SAN FRANCISCO UNIFIED SCHOOL DISTRICT  
2011 PROPOSITION A BOND PROGRAM  
VISITACION VALLEY MIDDLE SCHOOL

**INTERIM HOUSING & MODERNIZATION ADDENDUM NO. 1**

**PROJECT:** Visitacion Valley Middle School  
450 Raymond Ave., San Francisco, CA 94134

**DATE:** March 11, 2015

| SHEET NO.<br>ADD 01<br>SK C2.03.1 | ARCH. JOB #<br>13089<br>JOB NO. |

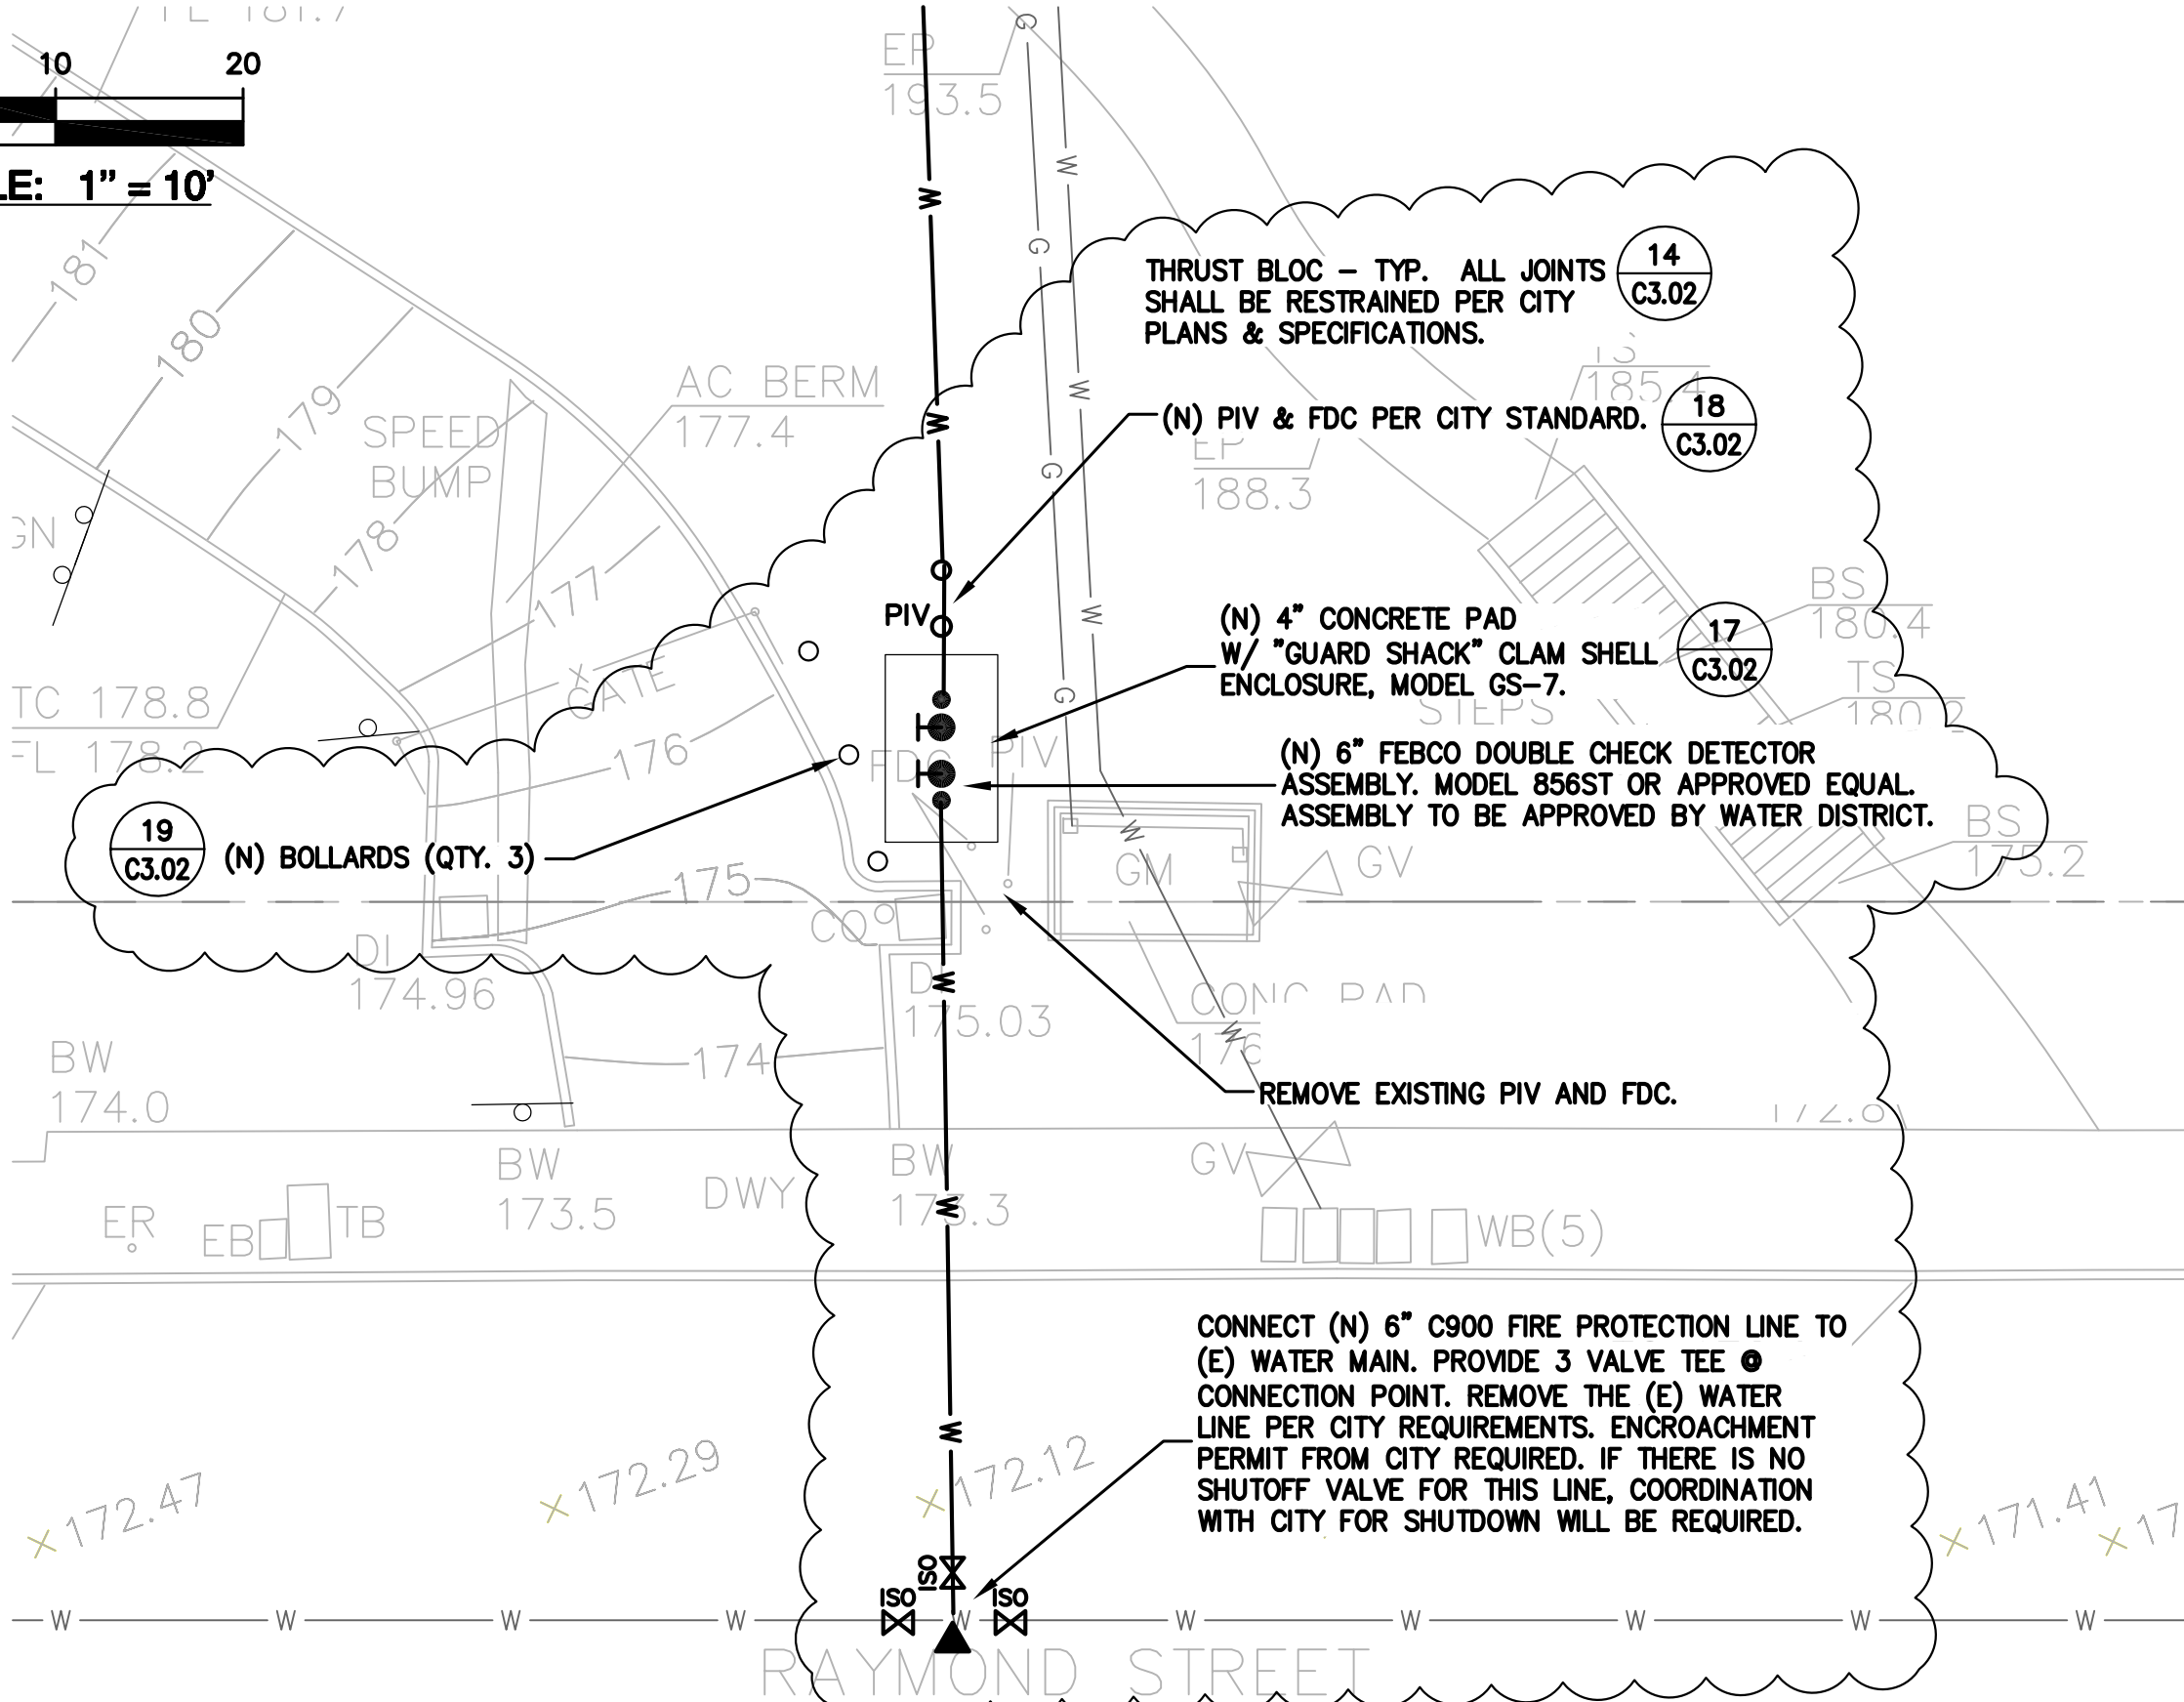
Description: Addition of back flow preventer and new FDC and PIV.  
See attached sketch SK C2.03.1

5 **CCTV ANALOG CAMERA RISER DIAGRAM**  
NOT TO SCALE

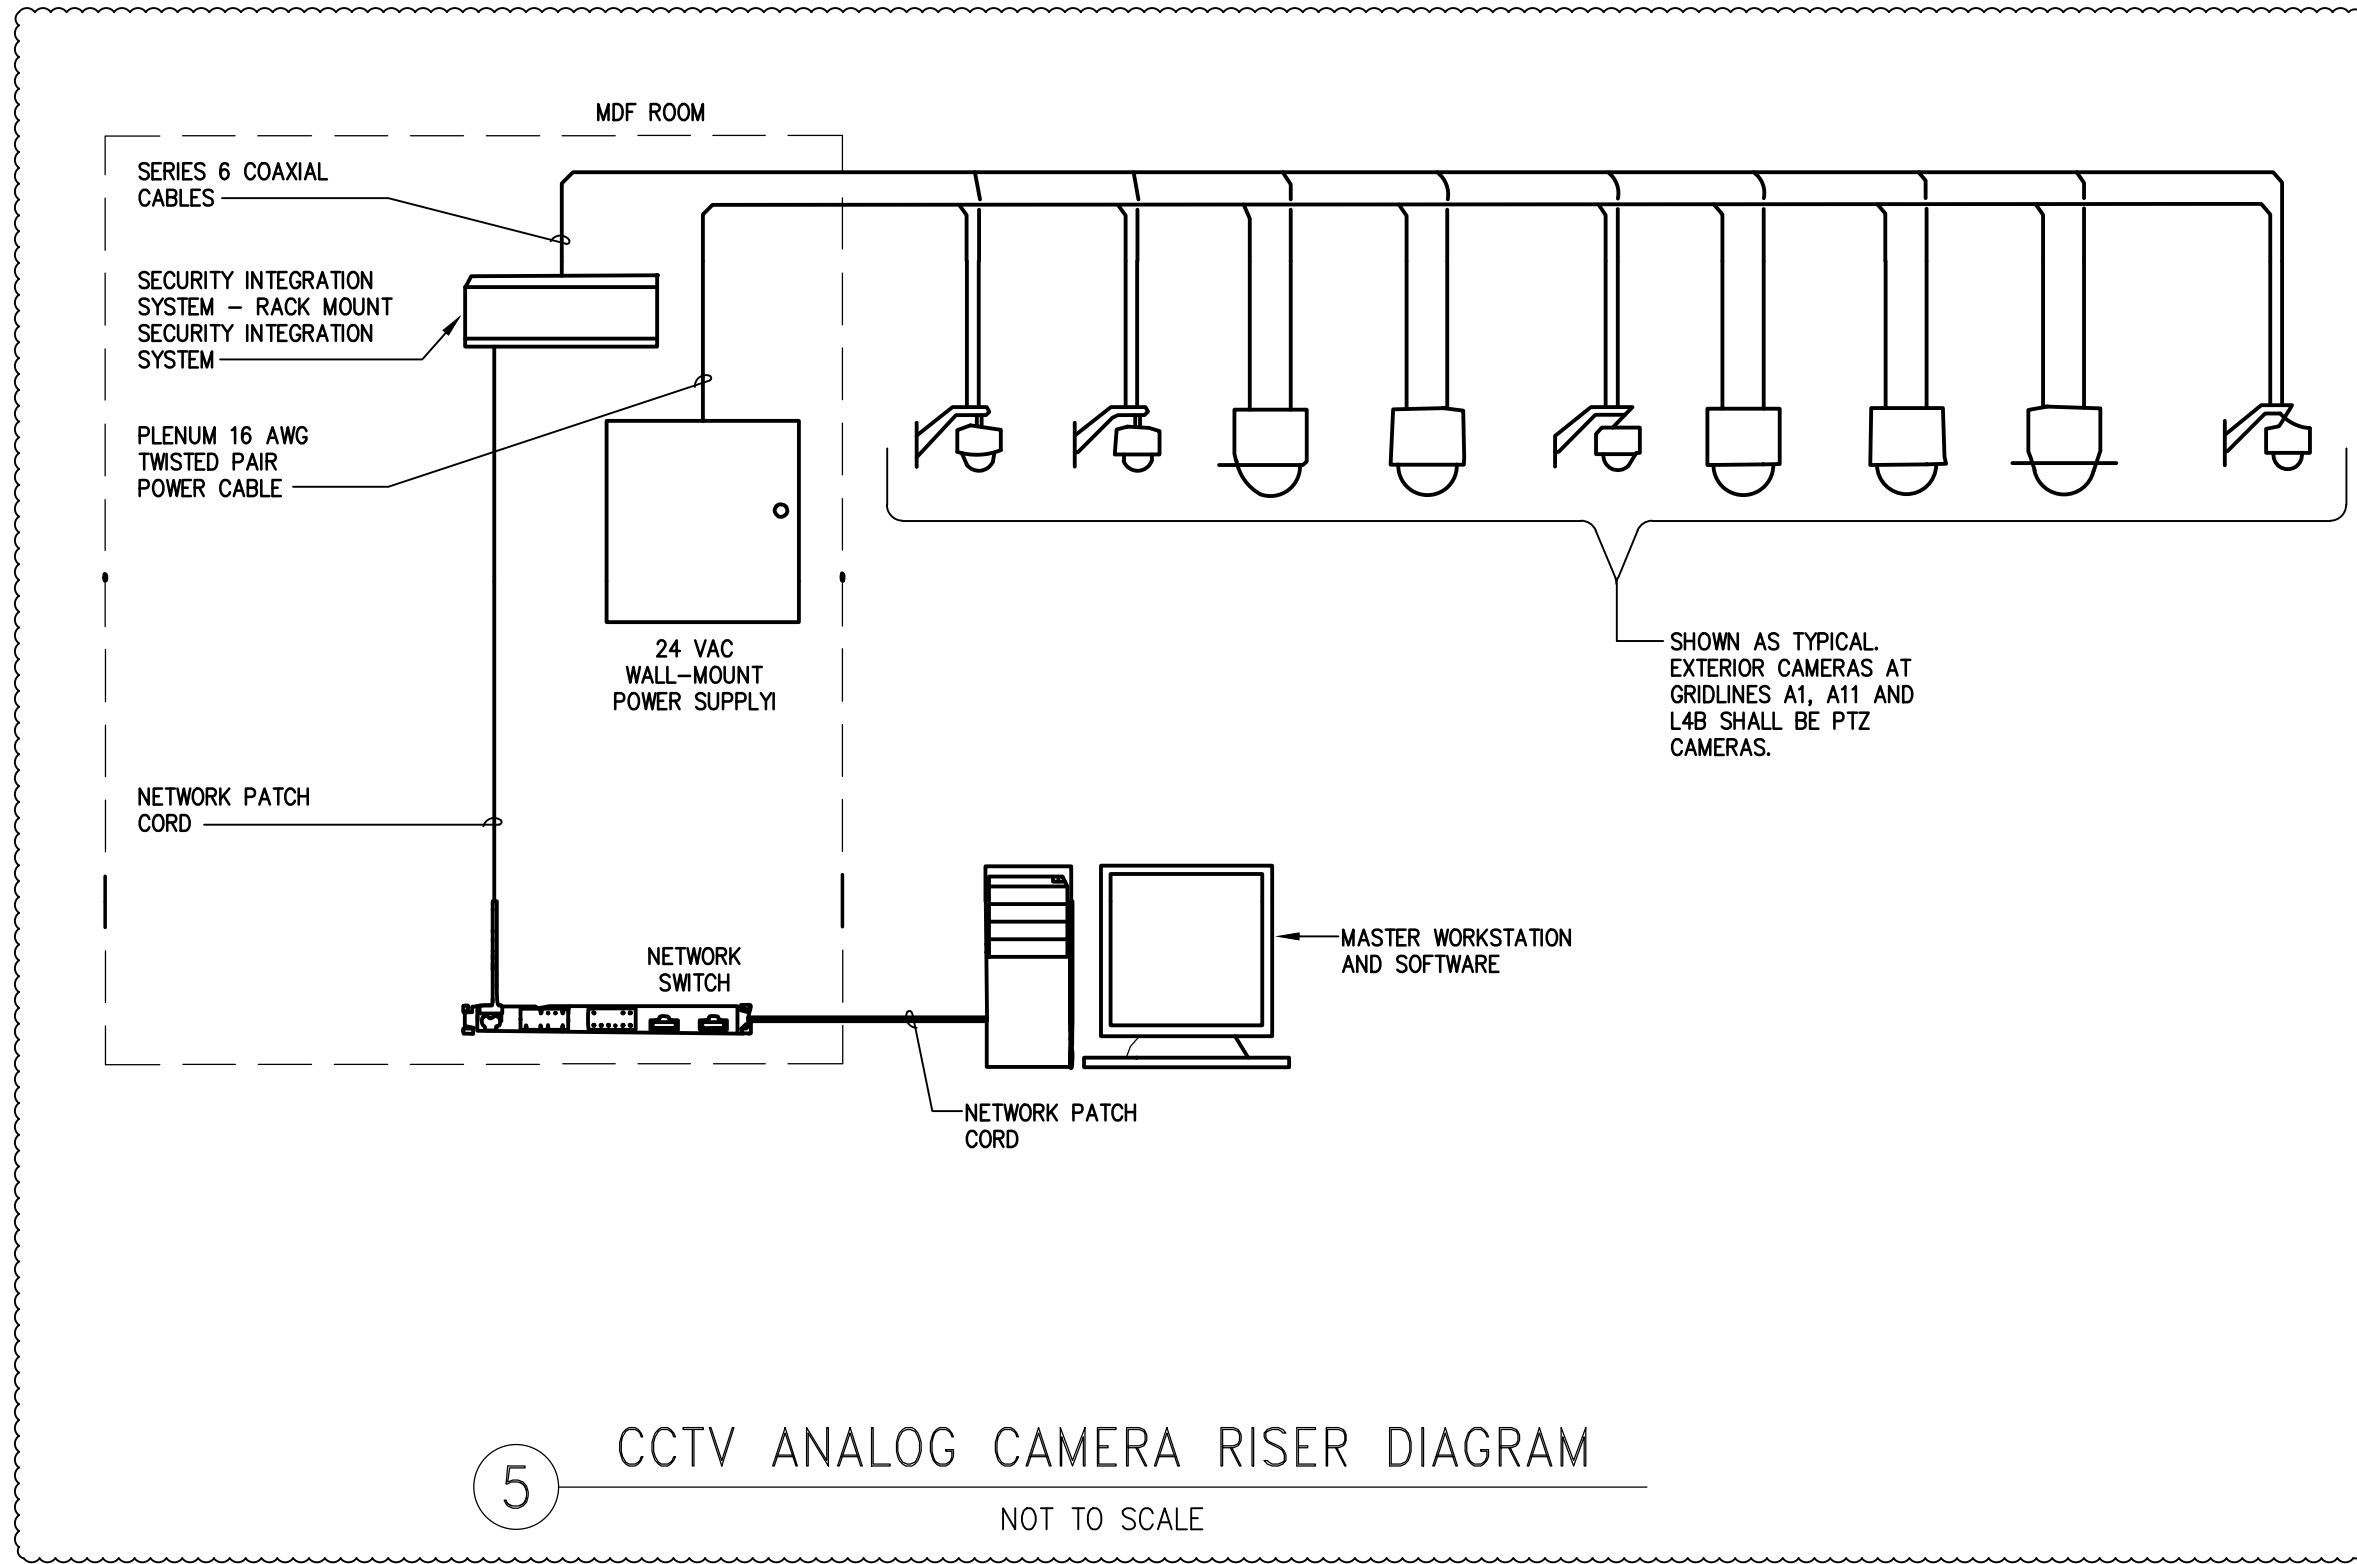
- Description: Add detail 5/E4 08 "CCTV ANALOG CAMERA RISER DIAGRAM". See sketch ADD.1 E4.08.1
- Description: Add detail 6/E4 08 "KERI SYSTEM ACCESS CONTROL ONE LINE DIAGRAM". See sketch ADD.1 E4.08.2.

1 FIRE ALARM SITE PLAN  
SCALE: 1" = 40'-0"

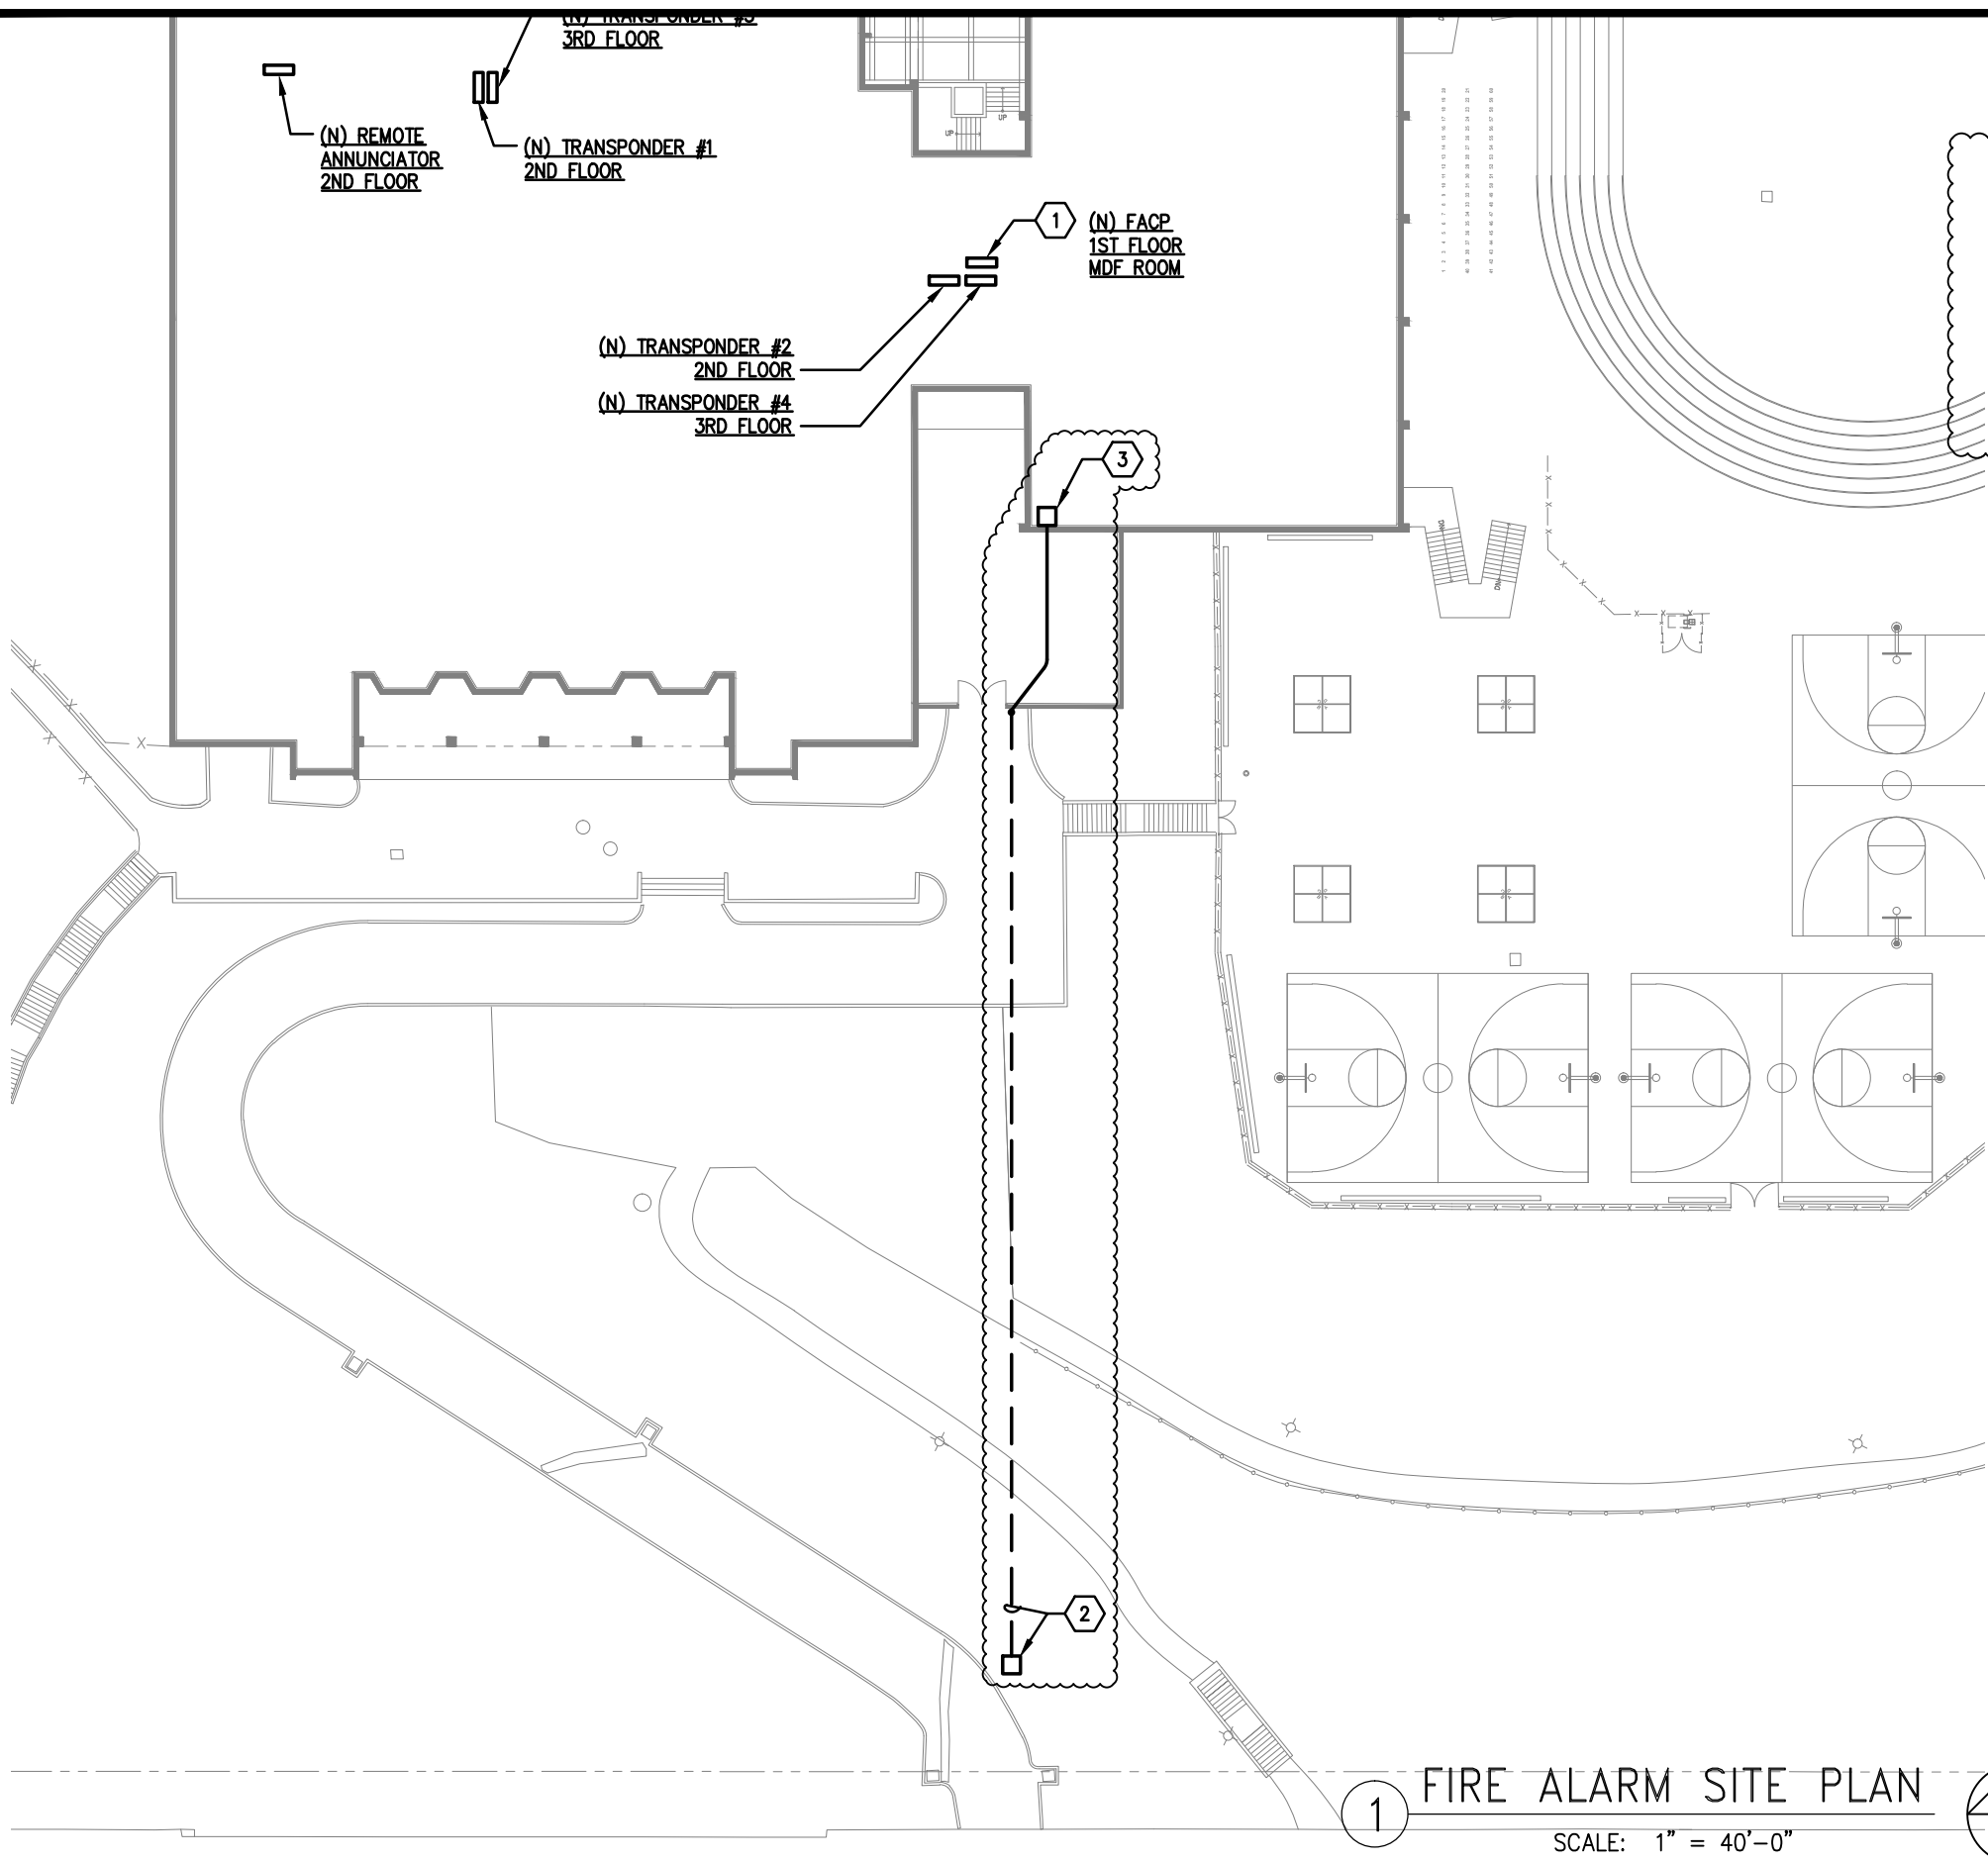
Description: Add new conduit and cabling from building to new PIV for fire alarm monitoring. See sketch ADD.1 FA1.01.1.

- 2 PROVIDE NEW 1 1/2" CONDUIT WITH (2) TYPE 'B' CABLES FOR TAMPER AND FLOW TO NEW PIV. COORDINATE TRENCH AND PIV LOCATION WITH CIVIL.
- 3 CONNECT CABLING AT FLOW SWITCH MONITOR MODULE IN BOILER ROOM SHOWN ON SHEET FA2.01. (2) MODULES SHALL BE INSTALLED ADJACENT TO INTERIOR FIRE RISER.
